Accessibility Evaluation Report

Complete Plan Sample

1234 Main St Small Town, CA 92113

CASp Evaluation

Finding: 14

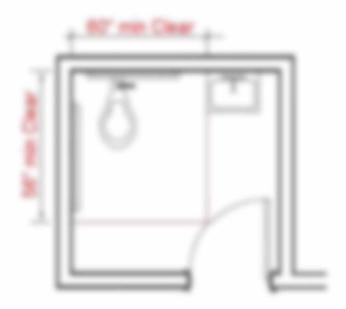
The required IR inches by 66 inches clear floor space for the water closel has been obstructed by the landony.

The olear floor space around the sedior closed shall be 66 inches occinion managered perpendicular from the olde sedl and 56 inches existings executed perpendicular from the way seal.

ports CBC 116 Section 116-65k.3.1

Observes amond a water obsert older for 60 notine (1000 not) intrinsic measured perpendicular from the olde well and 50 notine (1600 not) excessives measured perpendicular from the way wall. A minimum 60 notine, (1000 not) with and 40 notine, (1000 not) deep management papers older from the way wall. A minimum 60 notine, (1000 not) with and 40 notine, (1000 not) deep management graces older for provided in from of the water obsert.

Recommendation:

Relivate the locality to provide the required tollet observes a described herein
